Corsair Memory, Inc.

Declaration of Product Modifications

This is to request a Class II permissive change for FCC ID: 2AAFMRDA0048 originally granted on 03/17/2023.

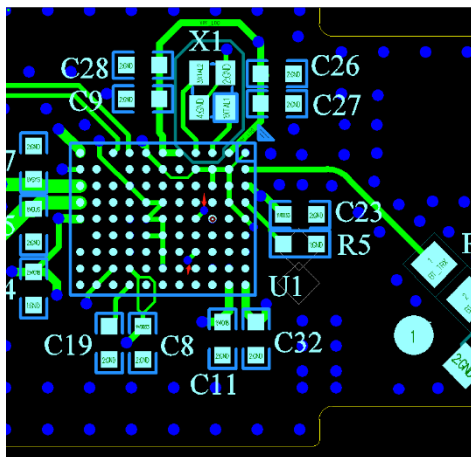
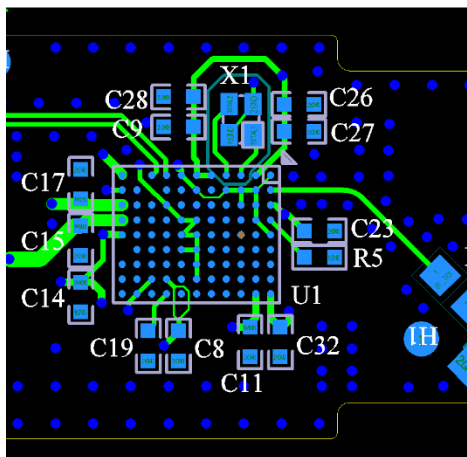
Change #1: Move the two holes shown by the arrows to the top of the BAG pad on the L1 layer, It can't see the change from the outside:
